**ADDENDUM
NO. 2**

November 3, 2022

**LIBERTY ELEMENTARY SCHOOL RENOVATIONS
Chesterton, IN 46304**

This Addendum consists of Pages ADD 2-1 through ADD 2-3 and attached Addendum No. 2 from Gibraltar Design dated November 2, 2022 and consisting of 7 pages, Specification Section 08 33 00 - Rolling Doors and Grilles, and 41 Drawings.

© GIBRALTAR DESIGN SHEET
AD101

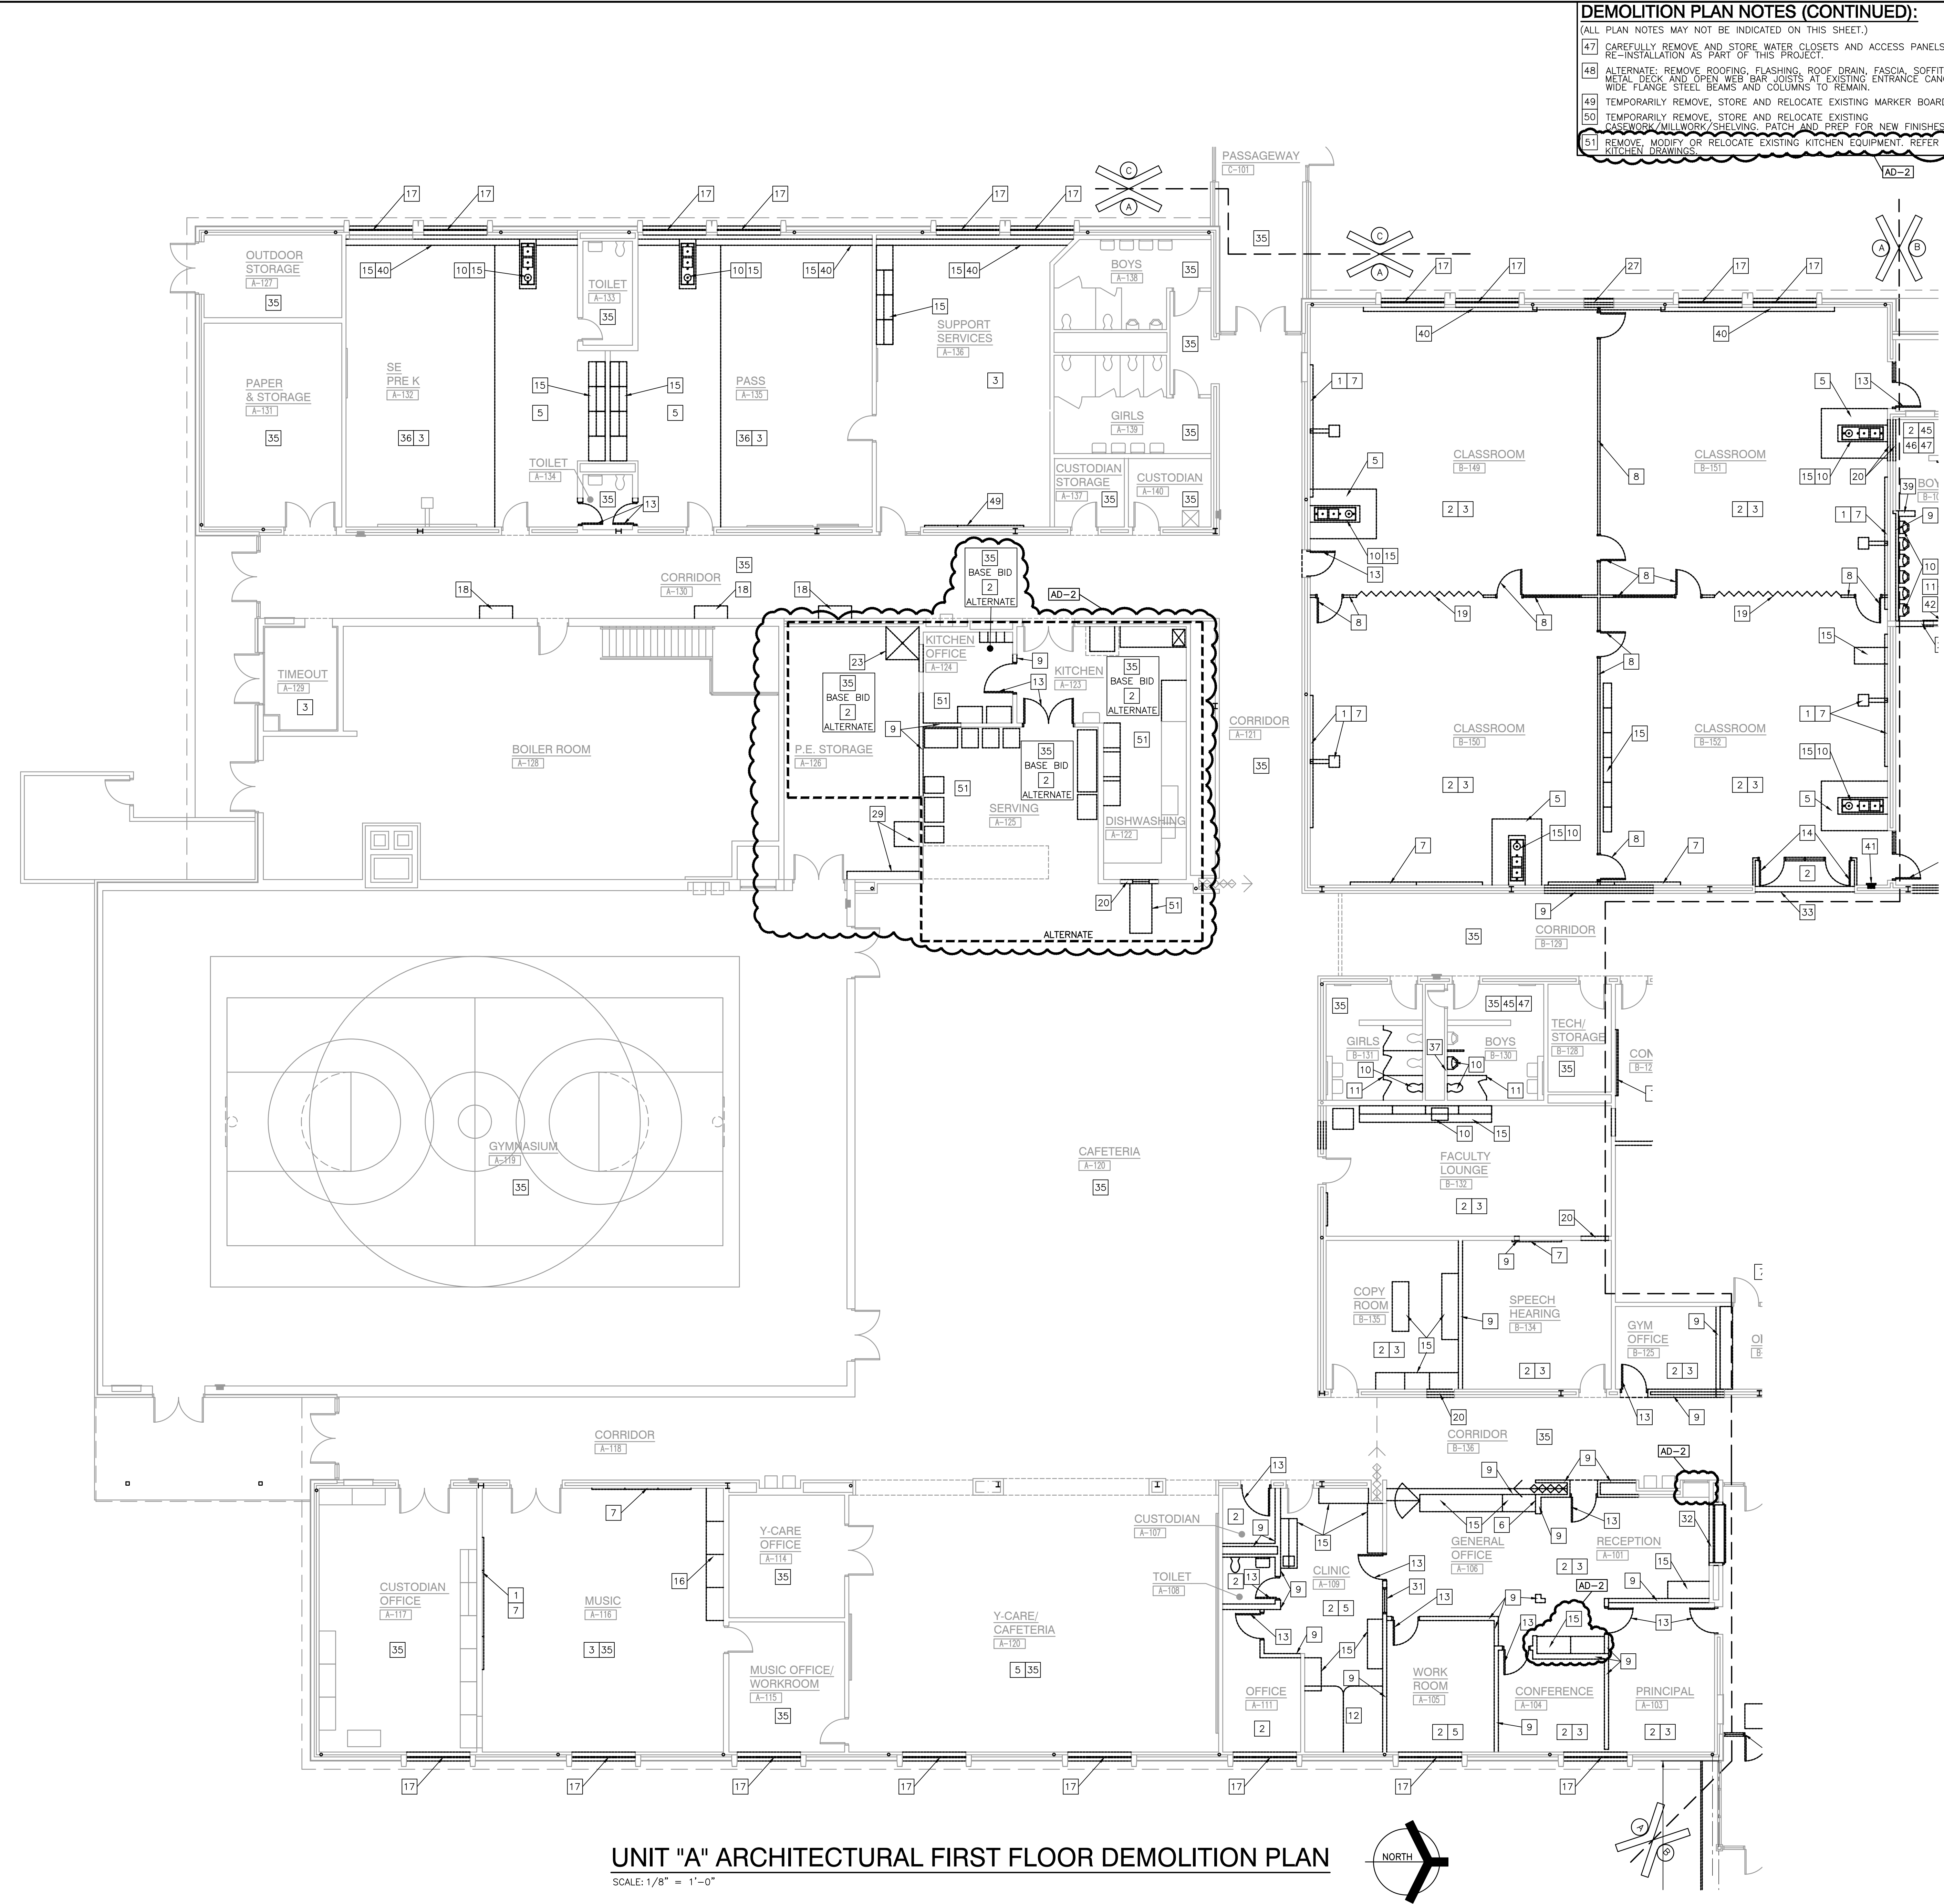
8. Sheet AD101

- A. Refer to revised full size drawings, included in this Addendum, for the following revisions:
 1. Add Demolition Plan Note 51.
 2. Add alternate area and additional notes and demolition items to Dish Washing A-122, Kitchen A-123, Kitchen Office A-124, Serving A-125, and P.E. Storage A-126.
 3. Update existing conditions to remain at Reception A-101.

© GIBRALTAR DESIGN SHEET
AD102

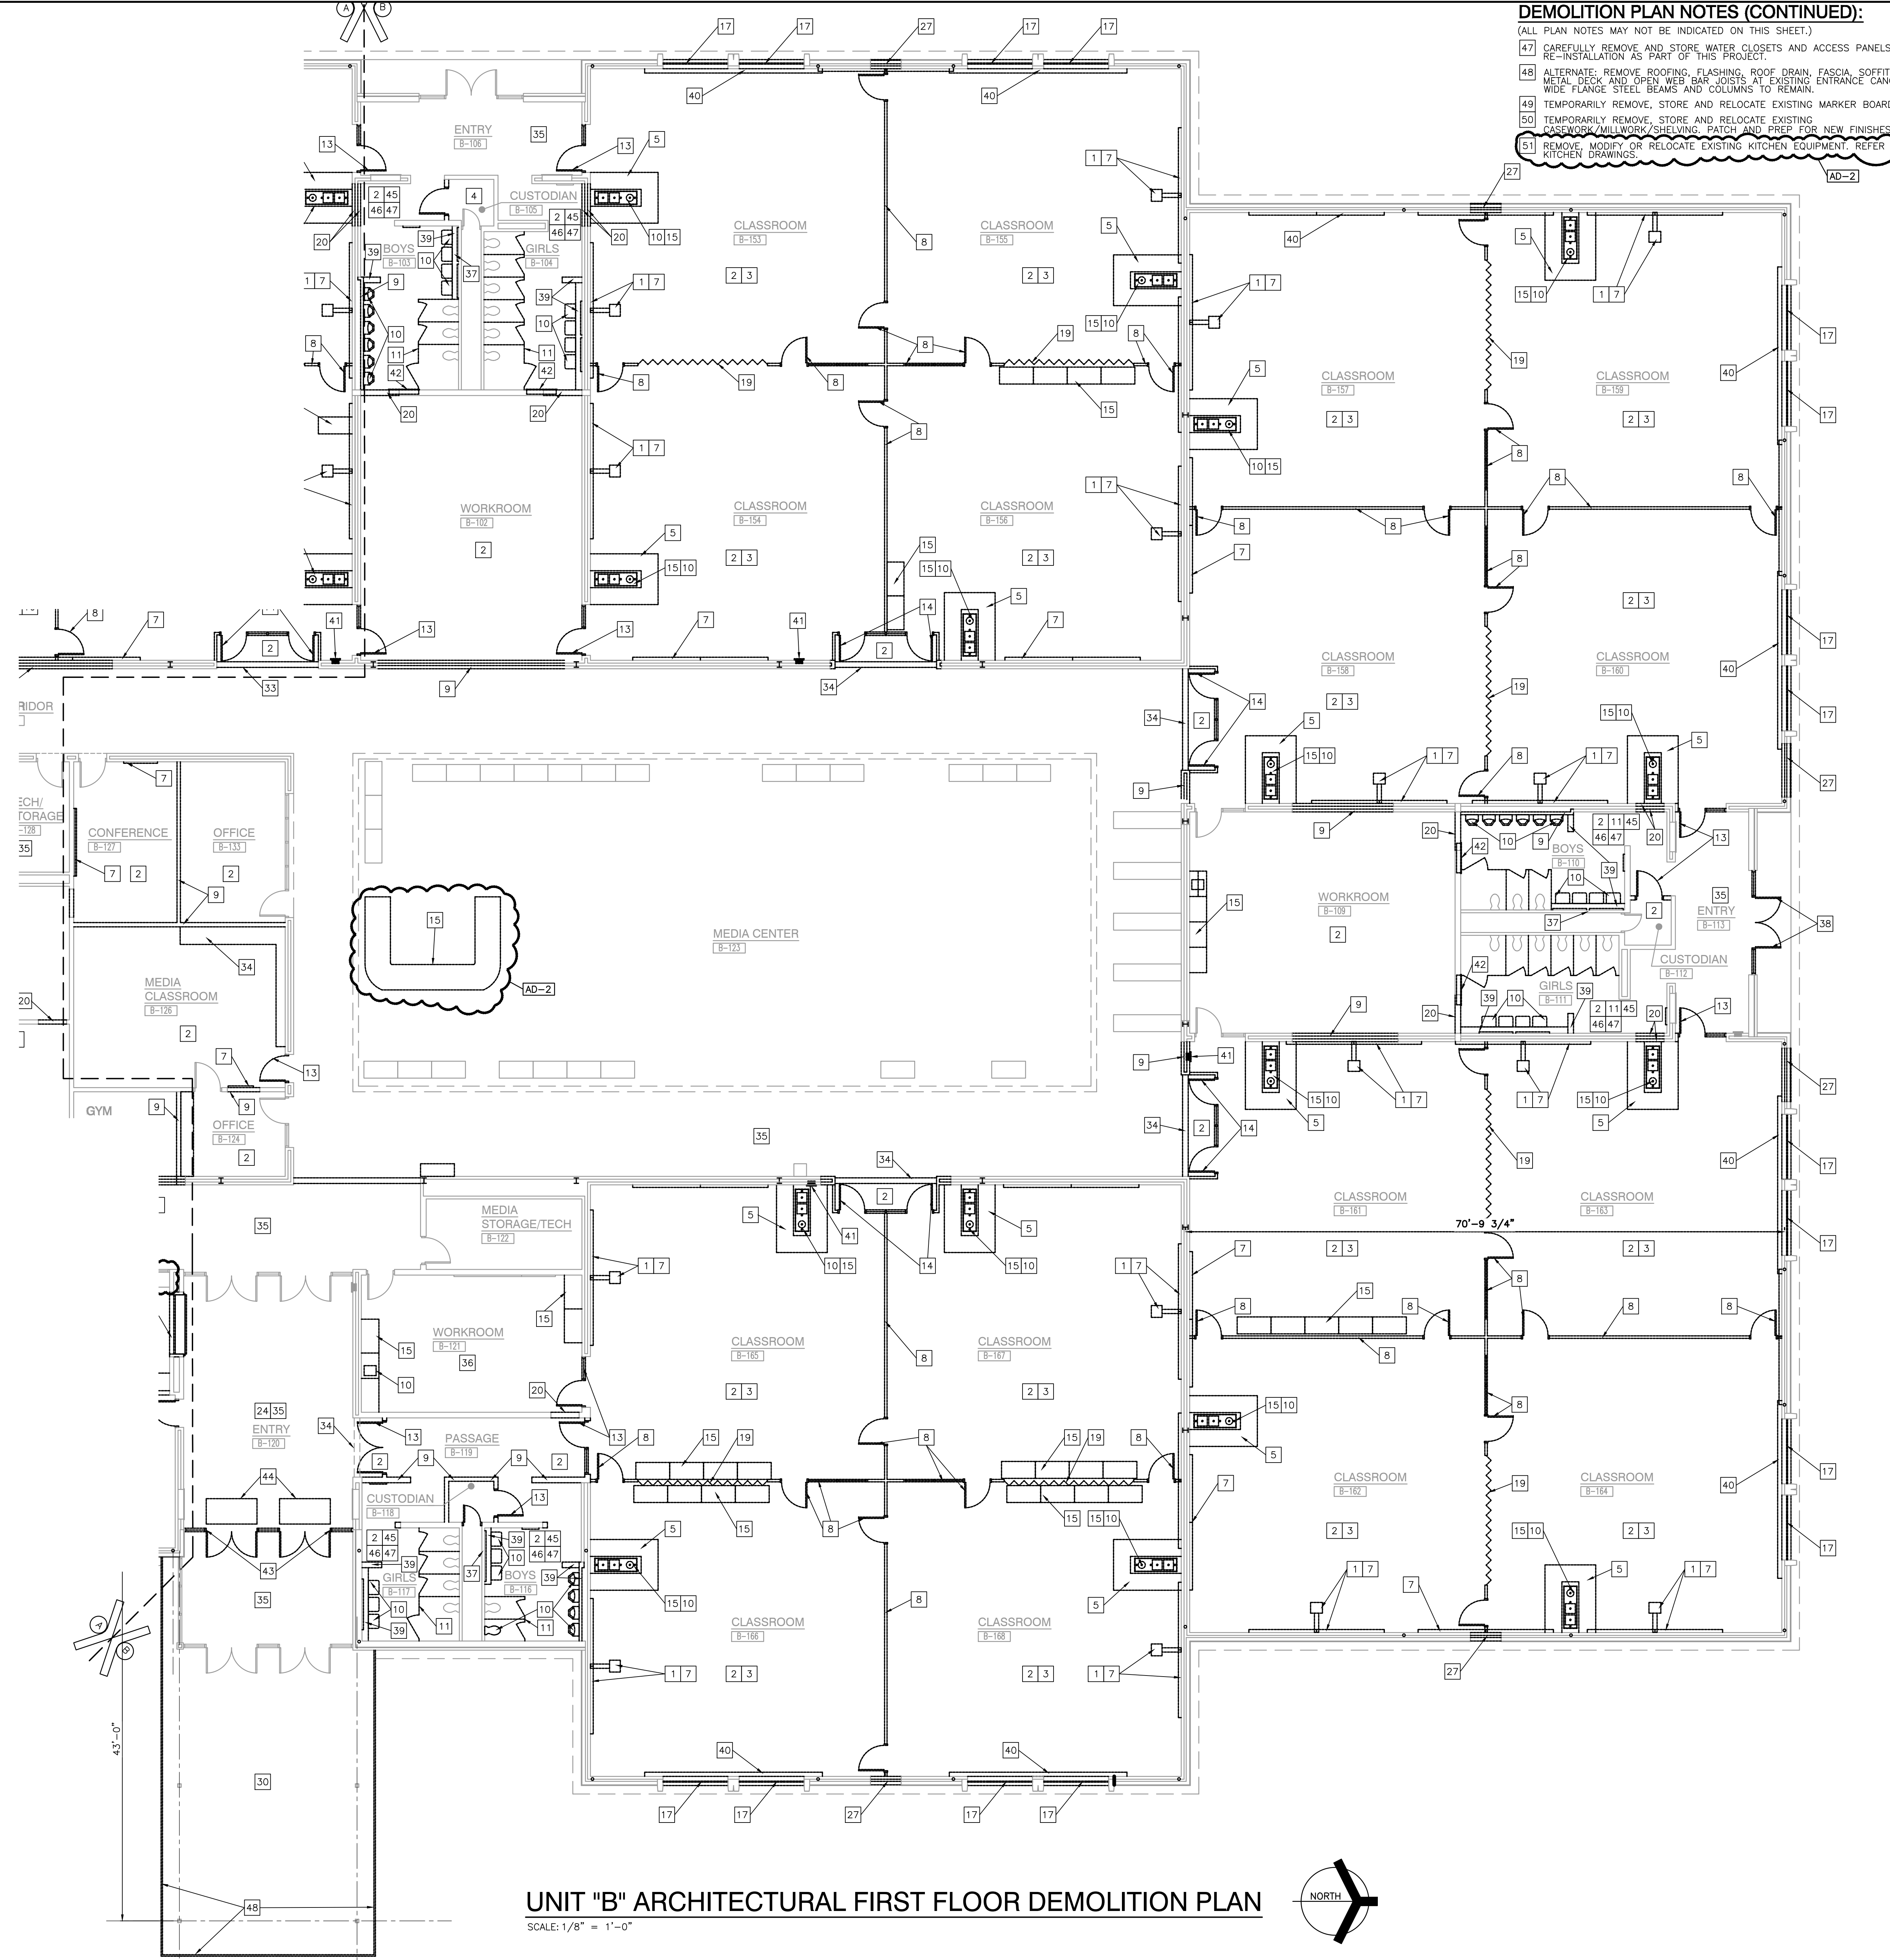
9. Sheet AD102

- A. Refer to revised full size drawings, included in this Addendum, for the following revisions:

1. Add Demolition Plan Note 51.
2. Add Demolition Plan Note 15 to circulation desk in Media Center B-123.

Wednesday, 11/2/2022 - 11:30 AM - LAST SAVED BY: JGRUBER
 Y:\21-137 DUNELAND SC - LIBERTY ES ADDITIONS AND RENOVATIONS\21-137 DRAWINGS\05 ARCH\AD103.DWG

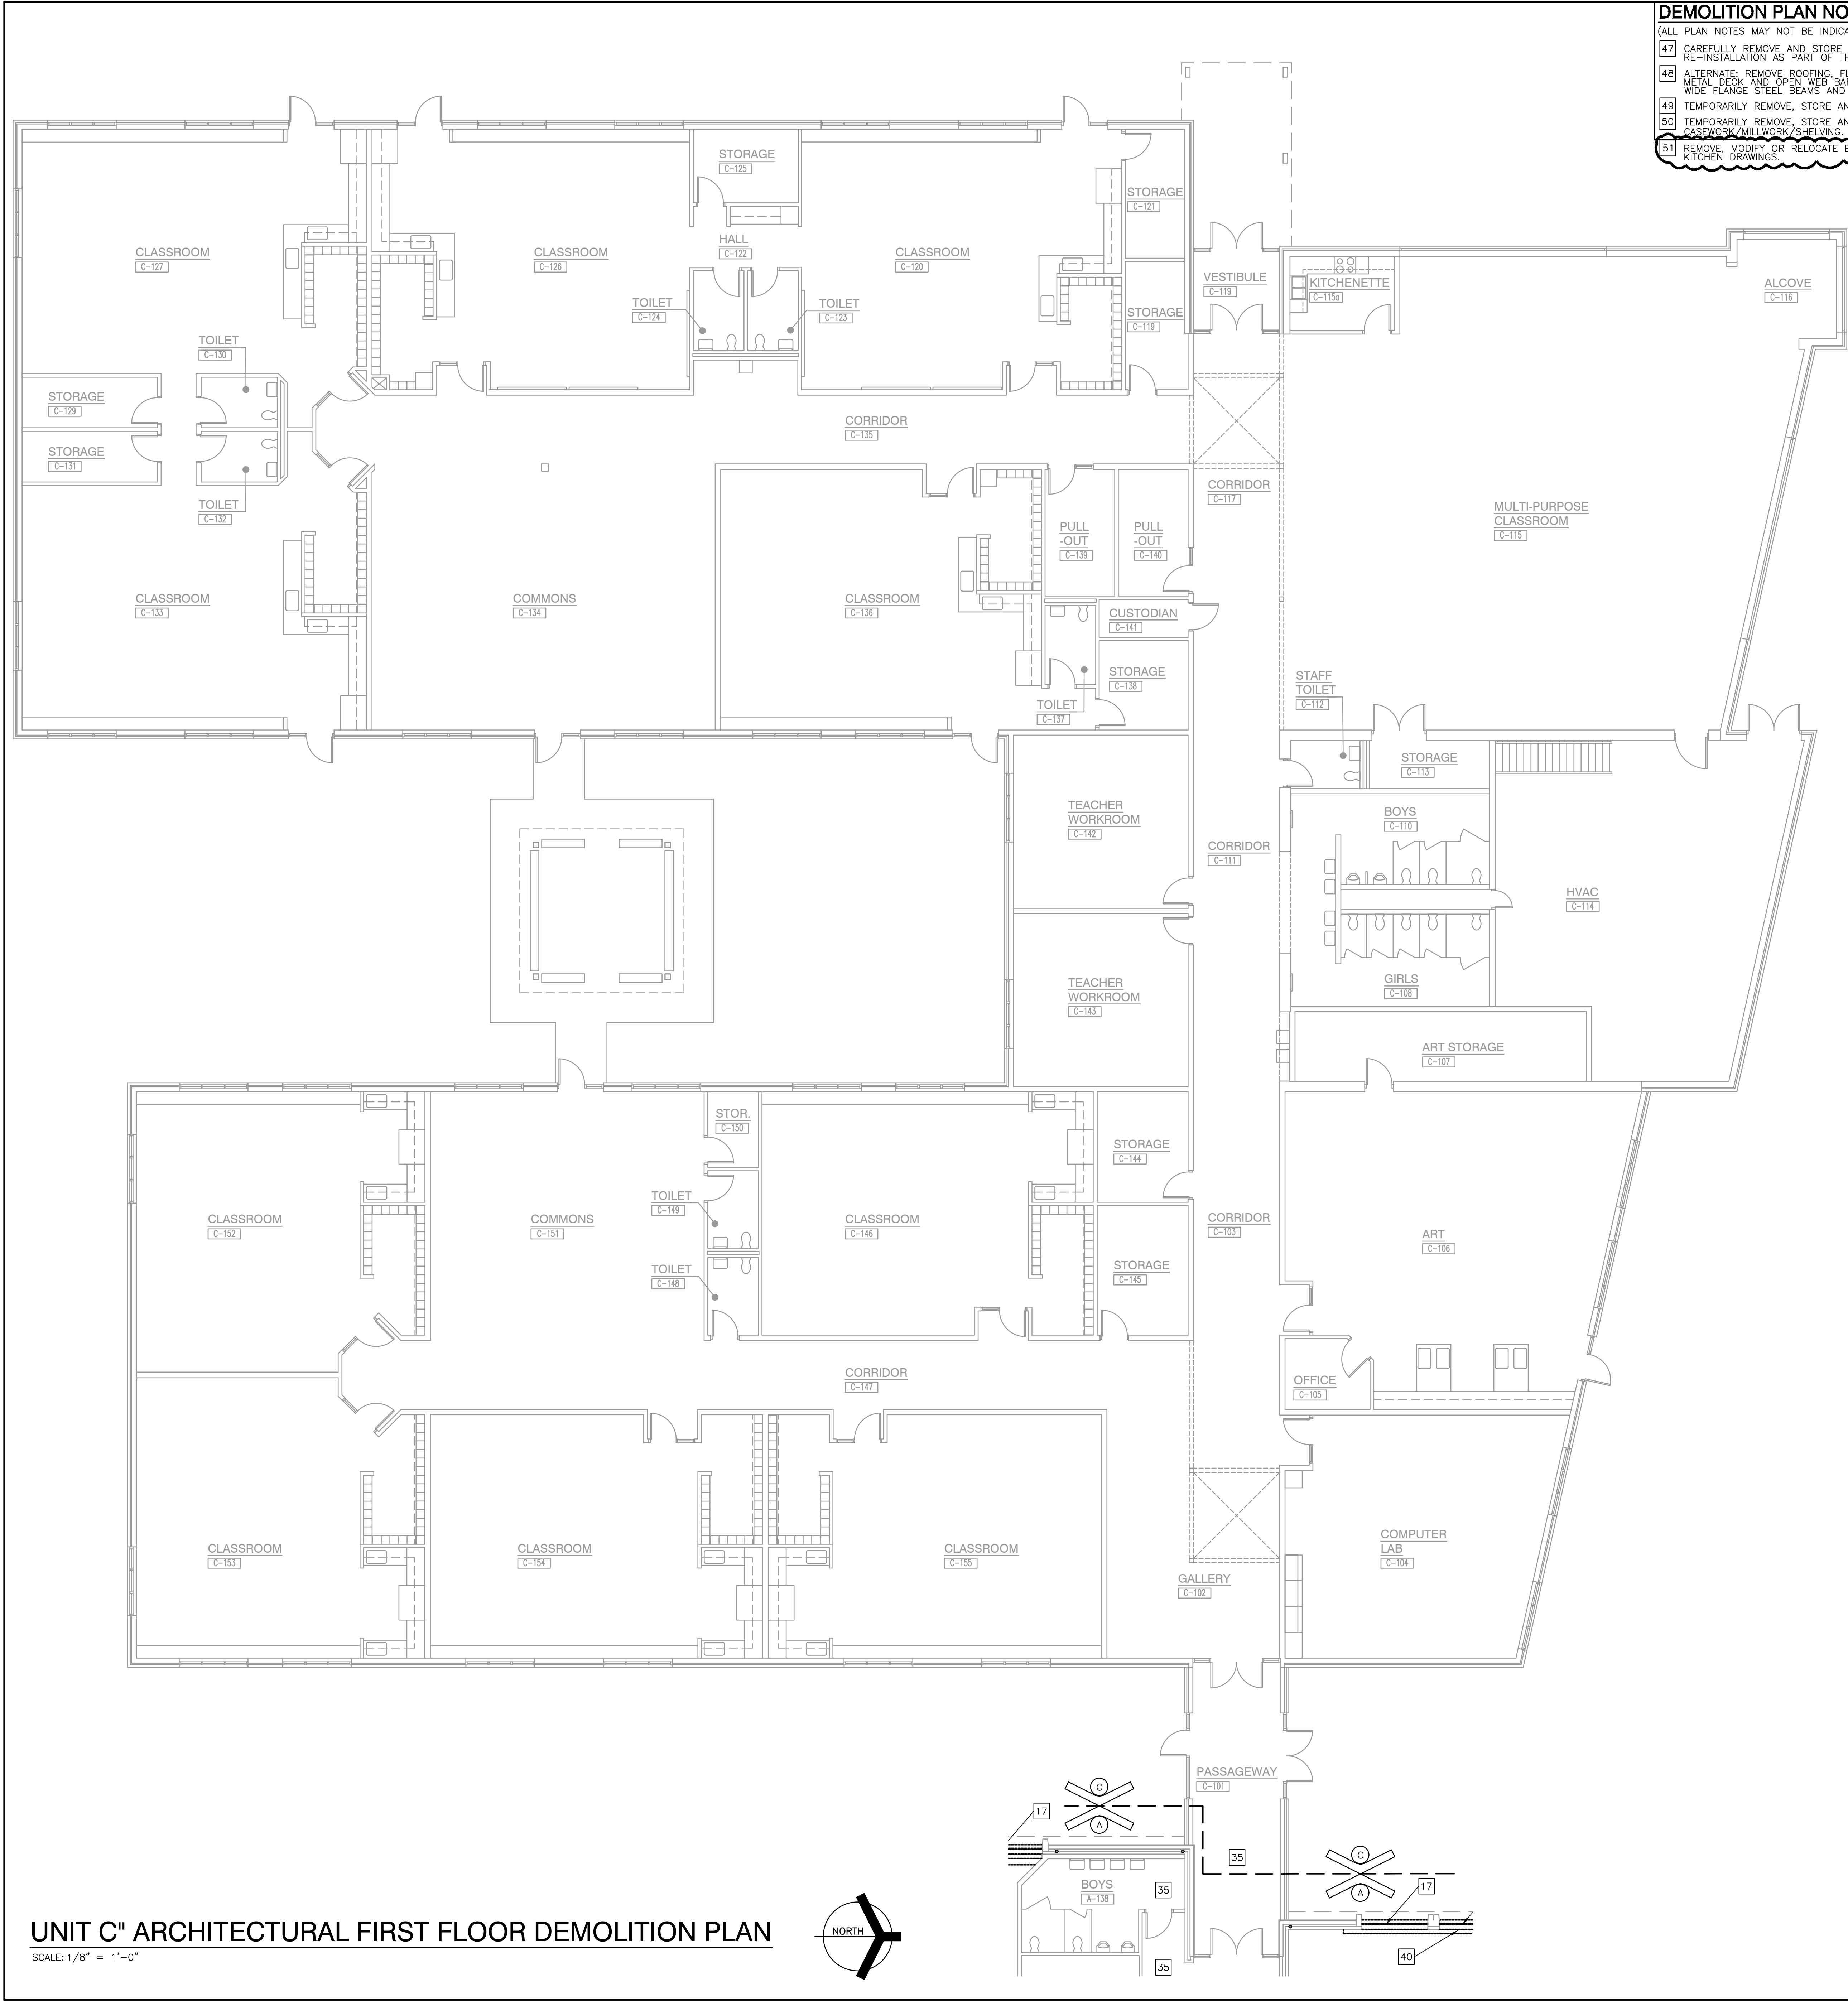
10. Sheet AD103

- A. Refer to revised full size drawings, included in this Addendum, for the following revisions:
1. Add Demolition Plan Note 51.
